MULE CANYON MINE

Environmental Impact Statement

**FINAL
ENVIRONMENTAL IMPACT STATEMENT
MULE CANYON MINE**

The Final Environmental Impact Statement (FEIS) provides responses to comments received by the Bureau of Land Management (BLM) during the public comment period on the Draft Environmental Impact Statement (DEIS) and includes, as appropriate, corrections or revisions to the DEIS based on these responses. The DEIS analyzed potential impacts associated with a proposal to develop, operate and reclaim a new surface gold mine and related facilities in north-central Nevada. The Proposed Action includes: 1) Development and operation of five open pits; 2) Dewatering of mine pits; 3) Construction of up to 14 overburden and interburden disposal areas; 4) Construction and operation of gold milling, processing, and tailings disposal facilities; 5) Construction and operation of required support and ancillary facilities and roads; and 6) Reclamation of mining-related disturbance and facilities. The responses and revisions include mitigation measures to prevent, control, or reduce potential project-related environmental impacts identified and discussed in the DEIS. The Agency Preferred Alter

FIGURE 1-2

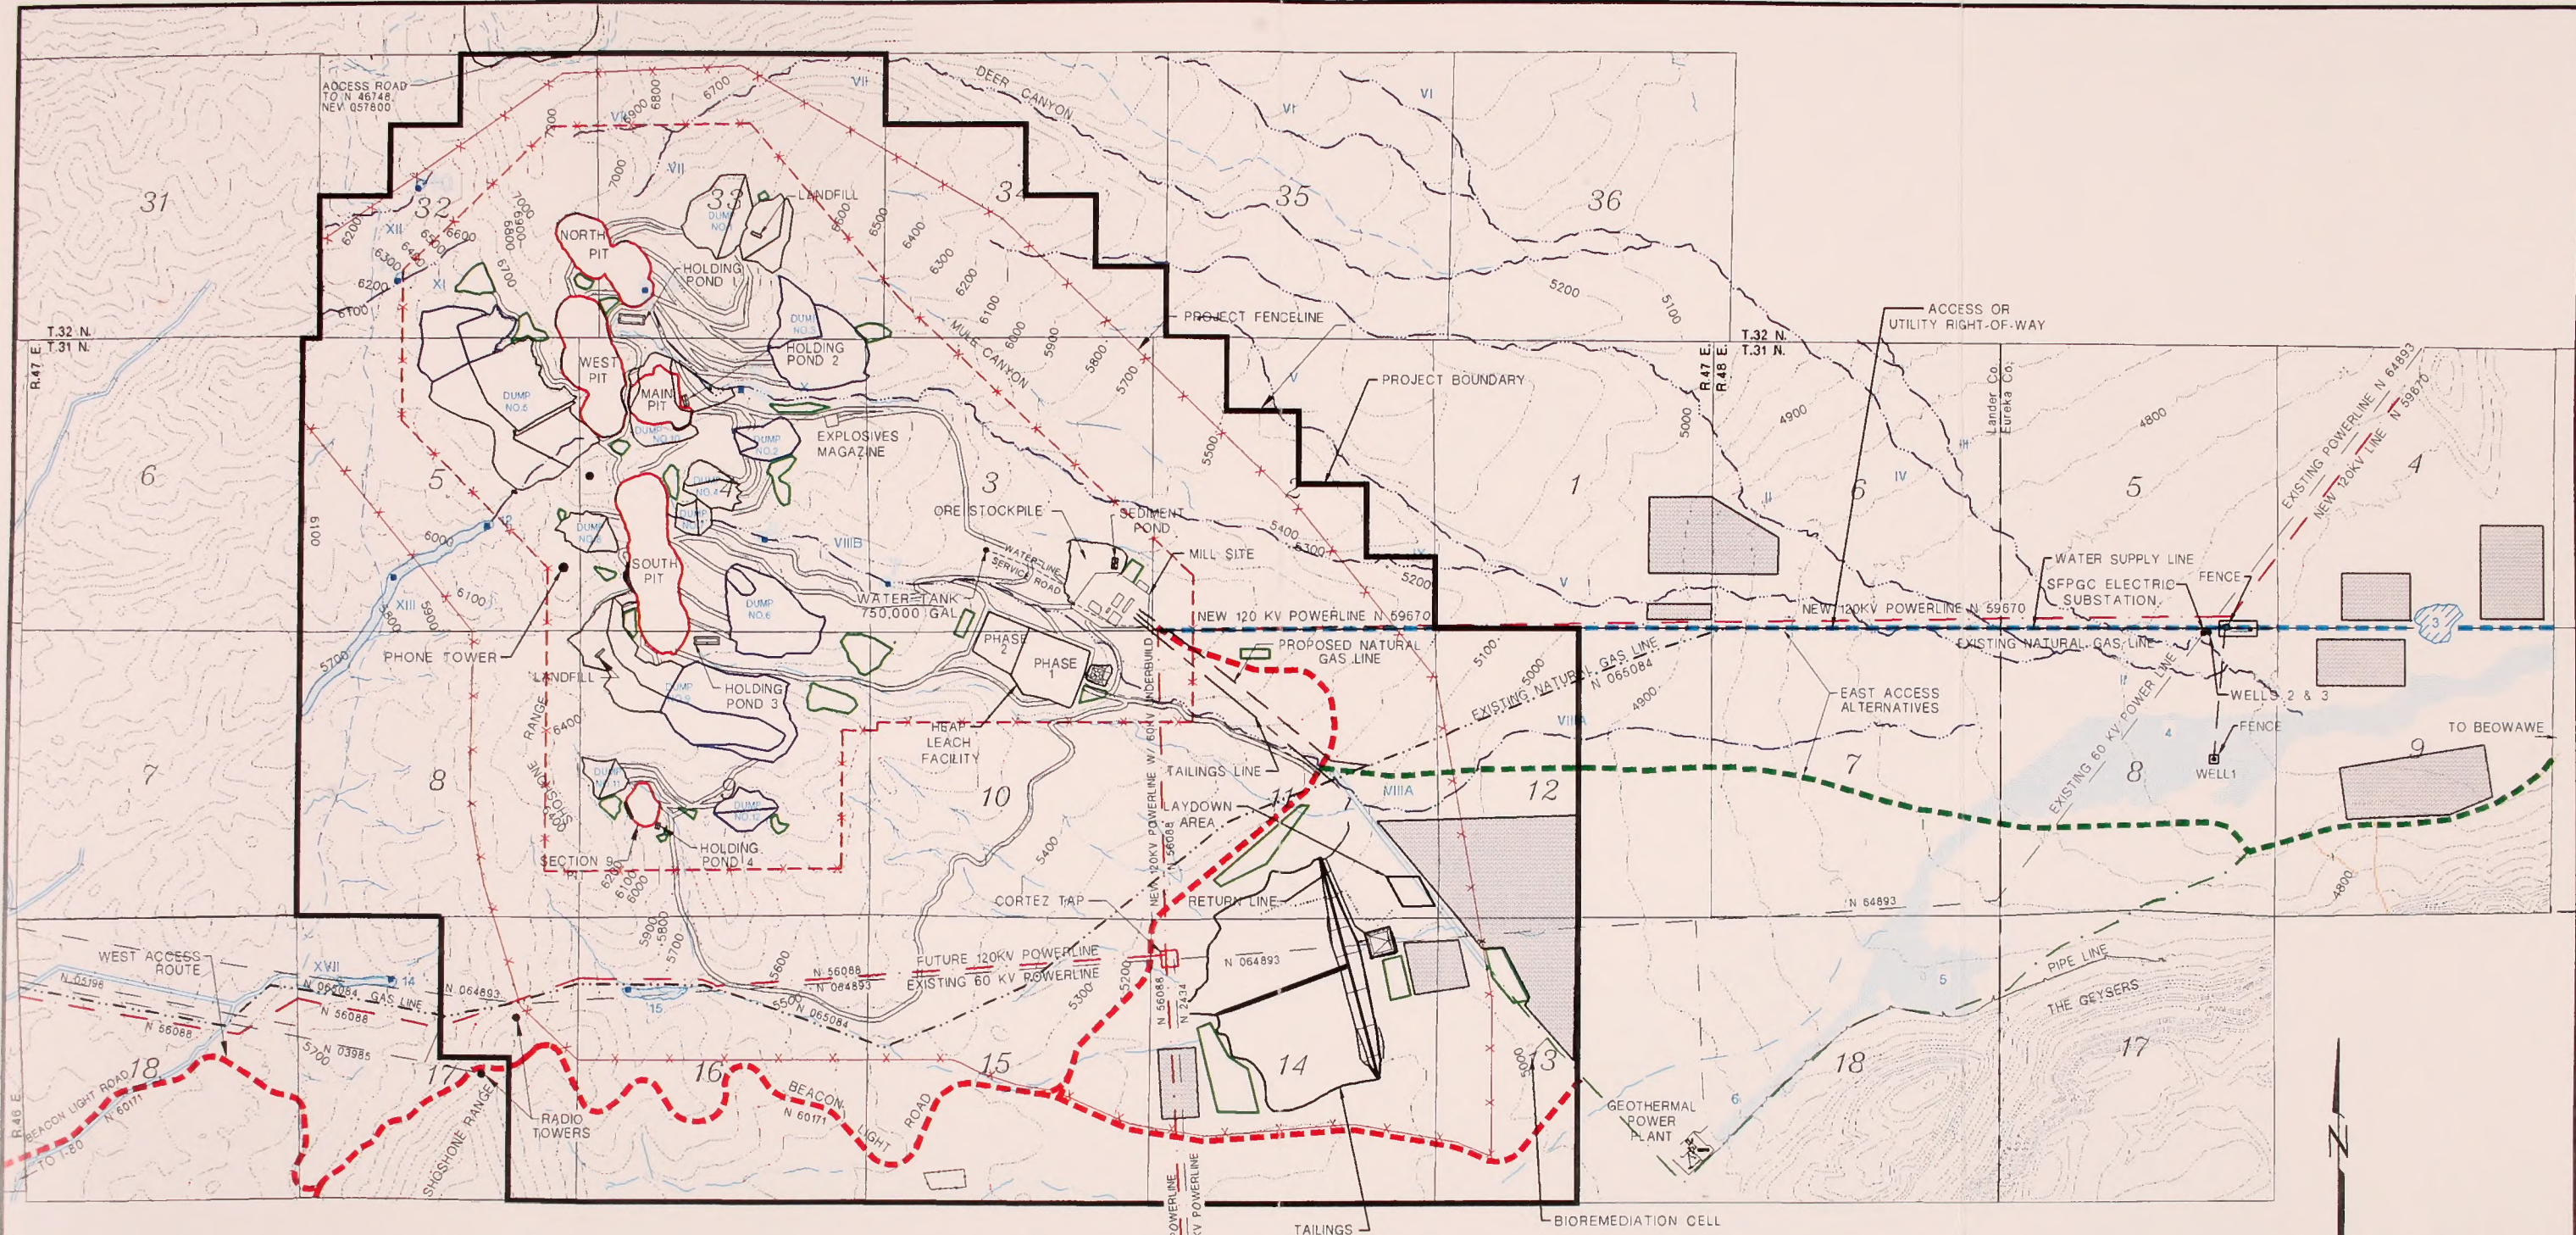
R 14.1 through R14.8 - Section 2.4.15, Figure 1-2, and Tables 2-1 through 2-4 of the FEIS document been revised as appropriate to reflect the corrections and clarifications provided by Sierra Pacific Power Company.

MULE CANYON MINE
FIGURE 3-10
WATER RIGHTS LOCATIONS

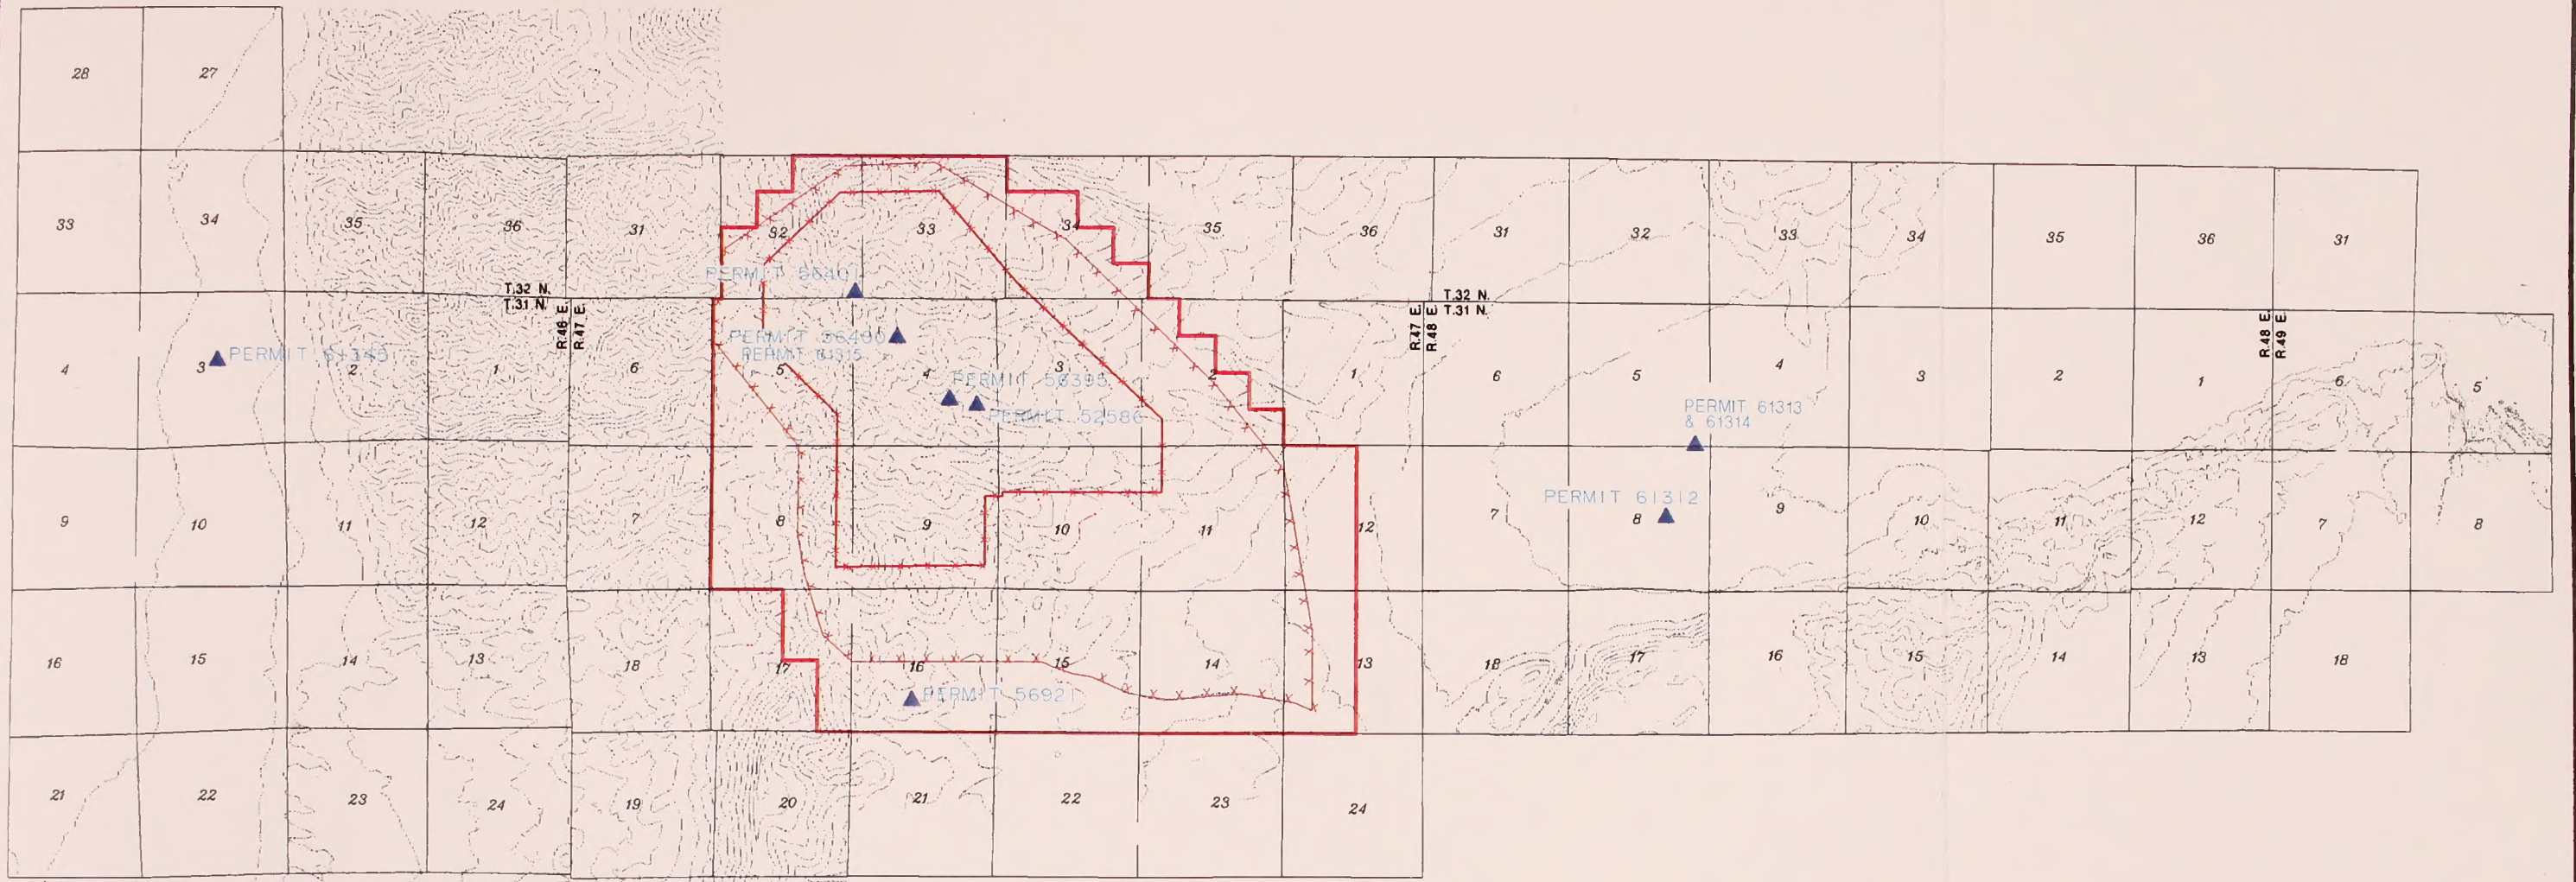
R 6.2 - Springs and seeps in the Project Area and any corresponding water rights and water rights filings based on current records of the DWR are summarized in Table 3-8 and their locations are shown on Figure 3-9. The discussion of water rights in Section 3.5.7 identifies those individuals or entities who have water rights or water rights filings on record with DWR as summarized in Table 3-8a and shown on Figure 3-10.

MULE CANYON MINE
FIGURE 3-11
STUDY AREA
GROUND WATER ELEVATION
MAP

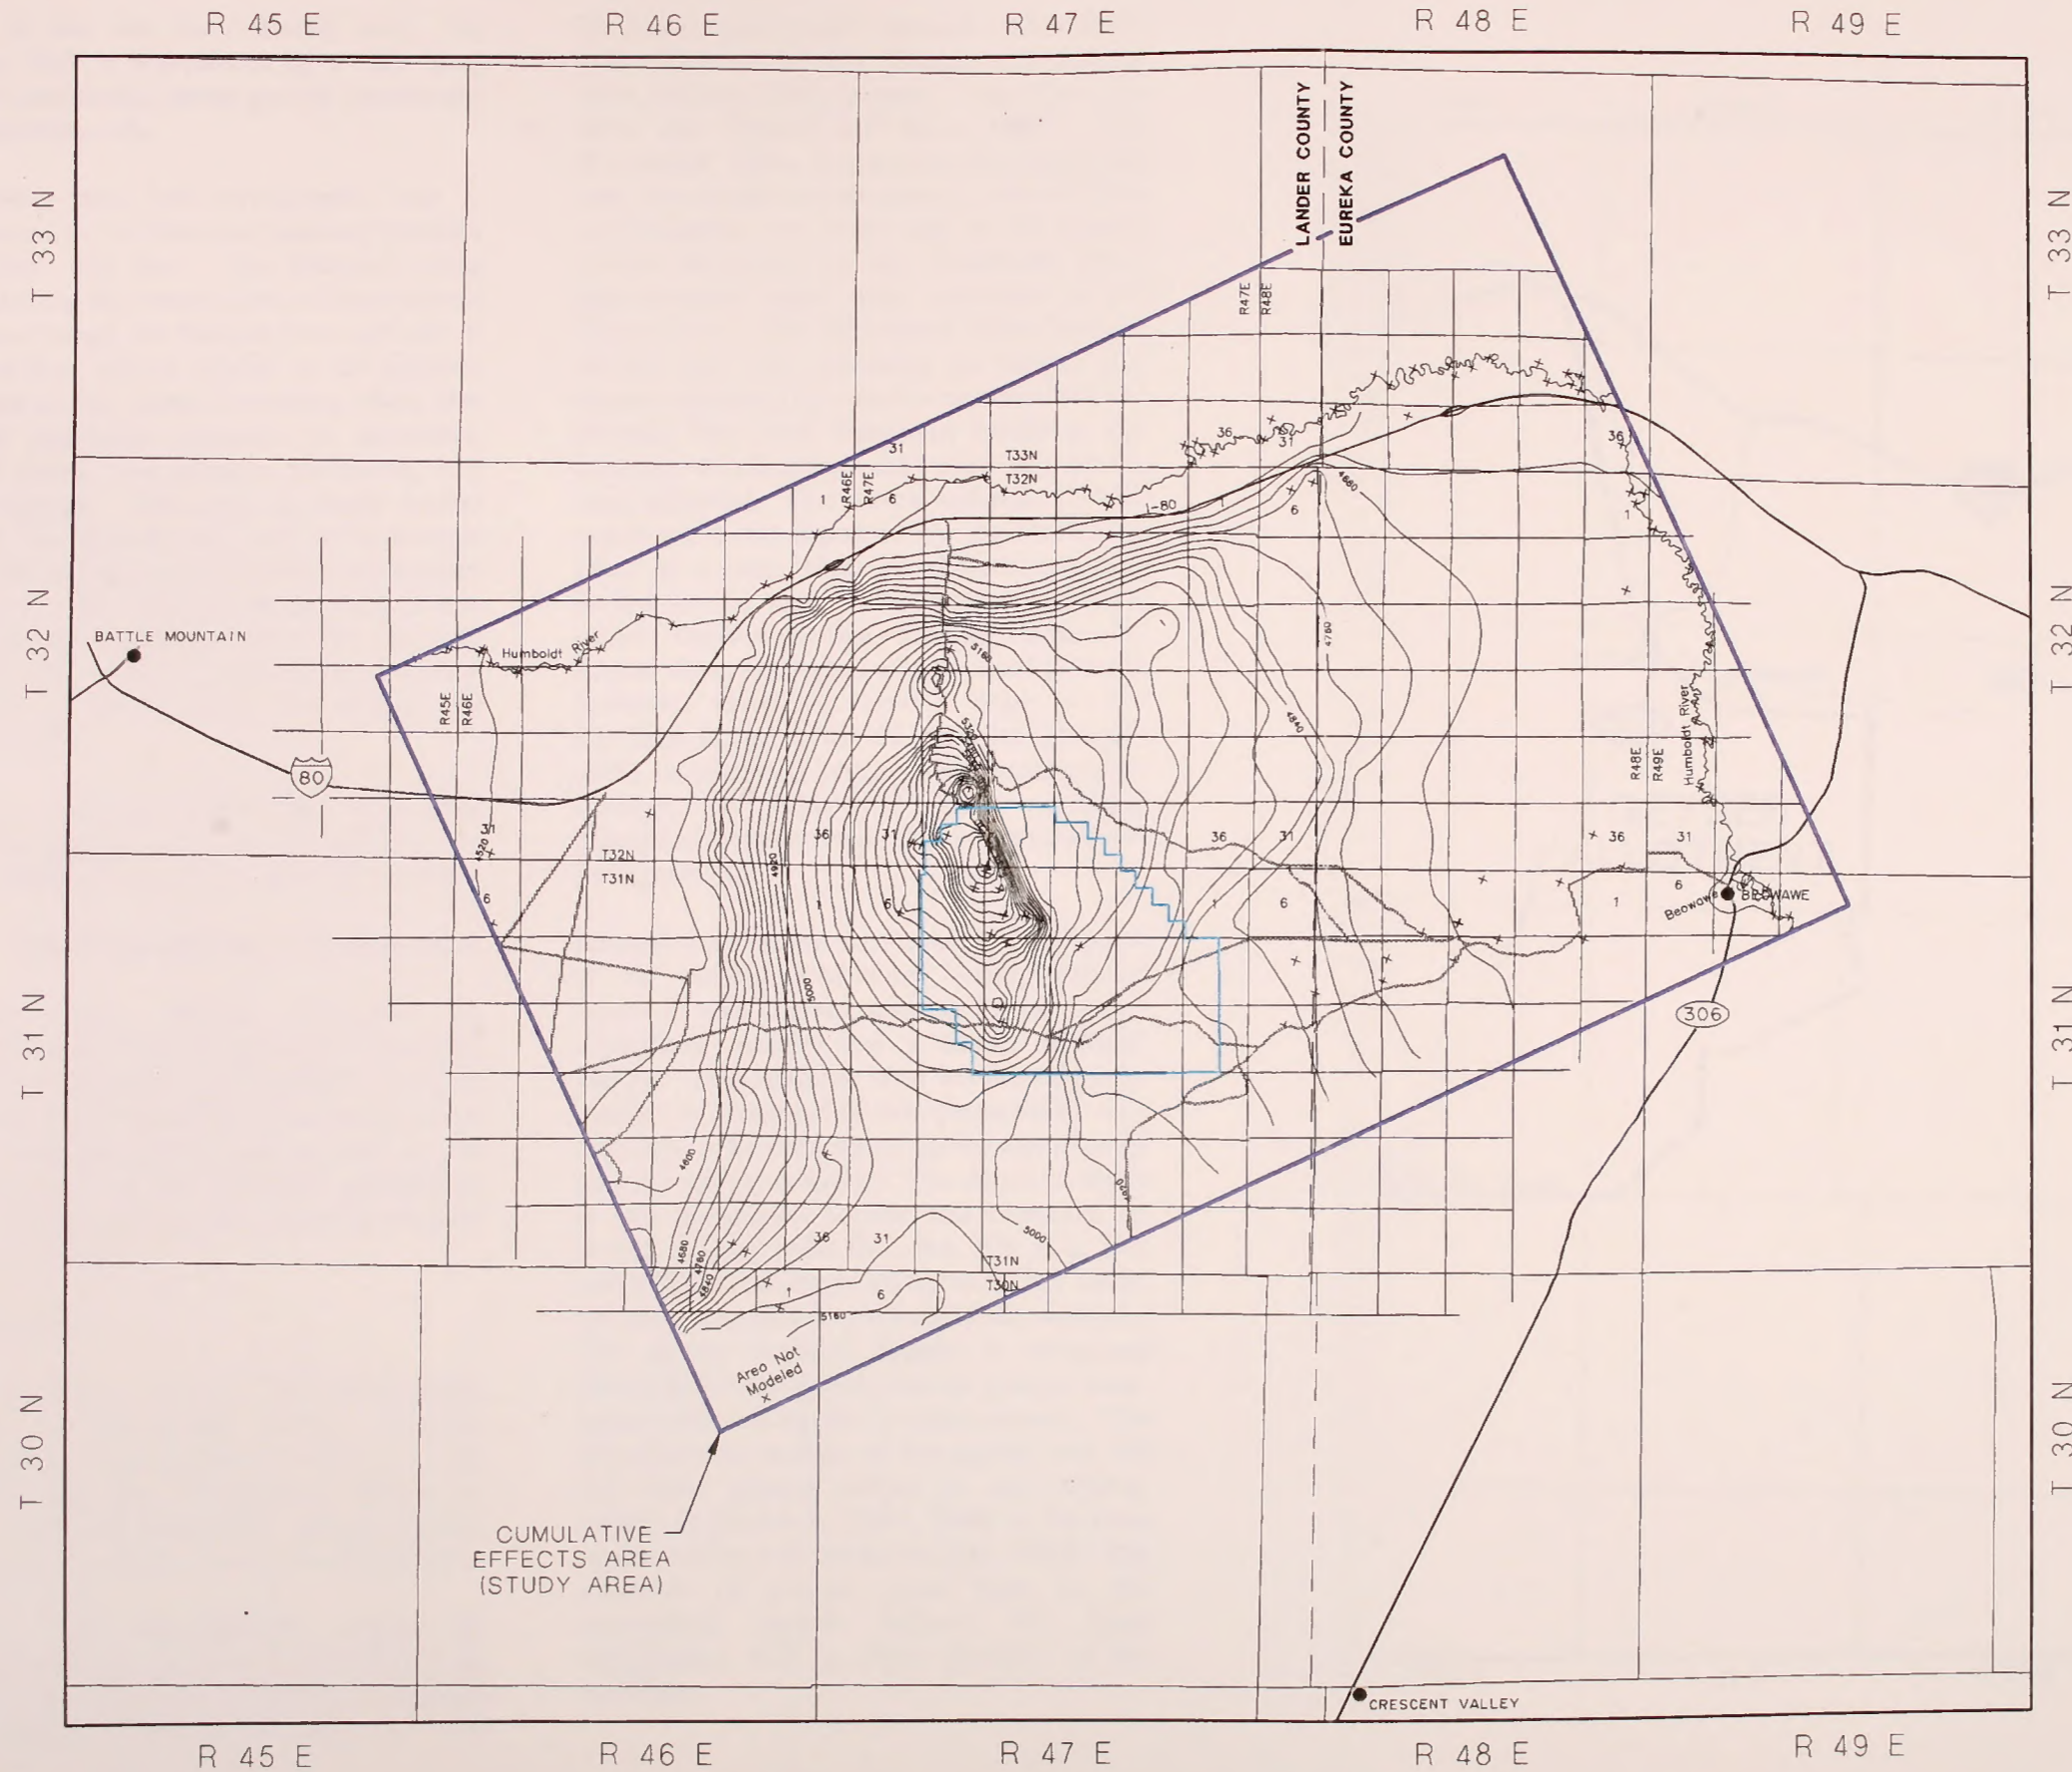
In the subsection "Volcanic Bedrock Aquifer," ground-water contours are shown in figure 3-11, not 3-13, and generalized flow directions are shown in figure 3-13, not 3-12.
